## HORSHAM DISTRICT COUNCIL CONSULTATION

<b>TO:</b>	Horsham District Council – Planning Dept
<b>LOCATION:</b>	Land to the South of Broadbridge Way Broadbridge Heath
<b>DESCRIPTION:</b>	Full Planning Application for the erection of 89no. residential dwellings comprising dwellings (54no.) and apartments (35no.), 36% affordable homes, creation of new vehicular access on to Sergent Way, provision of public open space, landscaping and drainage solutions
<b>REFERENCE:</b>	DC/25/0894
<b>RECOMMENDATION:</b>	<b>Holding objection / modification</b>
<b>RECOMMENDATION: 2<sup>nd</sup> Response in Red</b>	<b>Objection maintained, as modification is still needed to address Root Protection Area conflicts and concerns.</b>
<b>SUMMARY OF COMMENTS &amp; RECOMMENDATION:</b> The submitted Arboricultural method statement and Tree protection plan are a fair assessment of the tree-related impacts of the development proposals at the site. However, some modification to the site layout is needed to address Root Protection Area conflicts and likely future resident pressure due to poor tree-to-build relationships post-development.

PROPOSED SITE LAYOUT showing the carpark to the north of T31 & T19

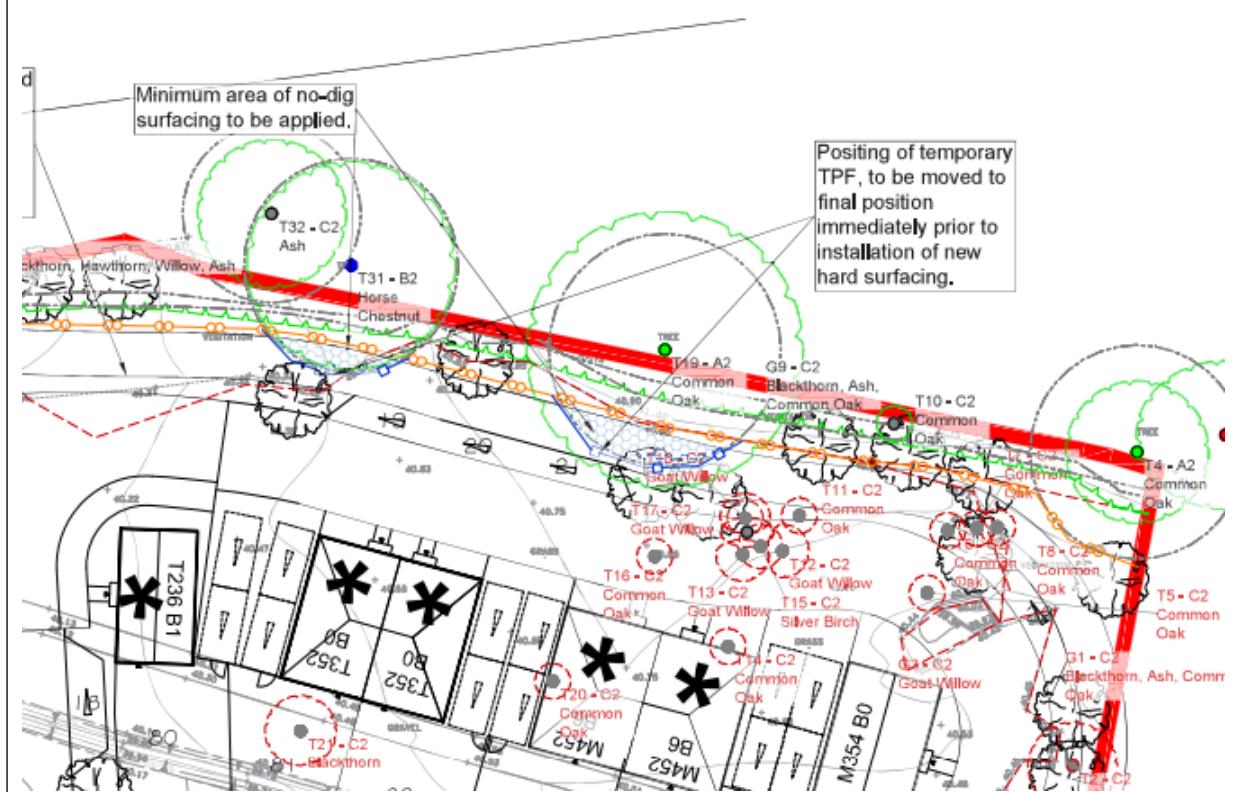
The Root Protection Areas (RPAs) for trees T31, T19, and T34 are still not considered to be plotted in accordance with BS5837:2012 (Section 4.6.2). whereby, existing off-site hardstanding within the northern portions of the RPAs of T31 and T19, and to the east of T34 where the RPA extends beneath Old Whickhurst Lane, has not been considered, offset, or modified to reflect the likely asymmetric rooting environment created by these off-site constraints.

BS5837:2012 requires that where existing obstacles or surfaces constrain root development, the RPA should be amended to show where roots are most likely to occur. In this case, the off-site car park to the north of T31 and T19, which is clearly visible on the indicative site plan, has been omitted from the Tree Protection Plan. This results in a misleading representation of the trees' functional rooting environment and raises concern as to why this constraint has not been factored into the arboricultural assessment, particularly as it was raised in my previous response.

For both T31 and T19, nearly half of the theoretical RPA is currently shown extending beneath an impermeable car park surface to the north. This means that any additional encroachment into the remaining functional (southern) portion of the RPA becomes significantly more critical. As such, based on the current assessment the proposed cycle path, to the south of the trees, in particular, would in my opinion, increase development within the RPA as is currently shown well beyond the 20% threshold generally accepted within BS5837, further exacerbating non-compliance with the BS.

Tree Protection Plan DWG NO: VYH24657-03A Sheet 2 of 2. It should be noted that the date on the new TPP has not been updated from the 17/04/2025 submission, despite the plans and site layout having been altered.

Given the likely southward rooting bias for T31 and T19, caused by the existing hardstanding, the proposed new road to the south is expected to lie partially or wholly within the functional RPAs of T31 and T34. No mitigation measures appear to have been proposed to address this conflict. As such, the scheme is not considered to be compliant with BS5837 and is likely to result in significant, delayed-onset harm to these trees, (which make an important contribution to local character and visual amenity of the area), over the next 5-10 years, due to construction activity and root loss/damage within their key rooting areas, unless the layout is amended accordingly.
